Re: Consultation on an Application

Planning Application Ref: PL/25/1131

Address: 108 Elm Park Road, Reading, RG30 2TJ

Proposal: Application for Approval of Details Reserved by Conditions 3 (Schedule of materials), 4 - (Energy), 6 - CMS (Construction Method Statement), 11 - (Landscaping and) 12 (Habitat Enhancement scheme) of application PL/23/1556

With reference to Landscape & Ecology As Proposed, August 2025, Drawing No. 90-10, Rev: A, I note the following:

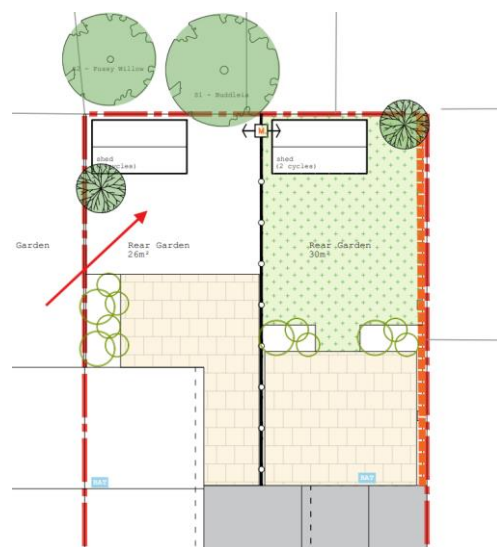
The plan positively incorporates the planting of two *Acer campestre* trees. As these are both of the same species, there is limited diversity. I suggest that the two replanted trees are of different species and thus meet with the aims of the Tree Strategy and the applicant might wish to consider more fastigate trees given the limited space available. Whilst the plan states the newly planted trees will be 10-12cm in girth, the trees height also need to be stated and should be of a minimum 3m in height at the time of planting. The incorporation of a privet hedge on the frontage is also positive.

There is no mention of the treatment of hard surfaces which is a requirement of the condition. I am unclear what the area is below (red arrow) as the surfacing has not been described here. This needs to be amended to detail the surfacing as it is currently unclear.

The means of enclosure has been specified as a brick wall around the perimeter and 1.2m high CB fence separating the two dwellings. I am concerned that the brick wall will require excavation to install the foundations and that it may have an impact on the RPA of the trees adjacent to the site – this was not considered at the application stage. Further details are required as if concrete is required for the foundations of the brick wall, which is toxic to trees, an impermeable liner will need to be used to prevent concrete leaching into the soil. Ecology will need to comment on mammal gap requirements.

No maintenance programme, to establish successful planting, has been provided which is a clear requirement of the condition.

No tree pit specifications have been provided.

The plan does not demonstrate when the planting will occur or that if the trees and plants die, become damaged, diseased or are removed within 5 years of planting that they will be replaced.

To conclude, due to missing information, the requirements of the condition have not been met. Further details are required regarding the boundary brick wall and its requirements for foundations. The tree species choice also needs to be revised to include a range of species.
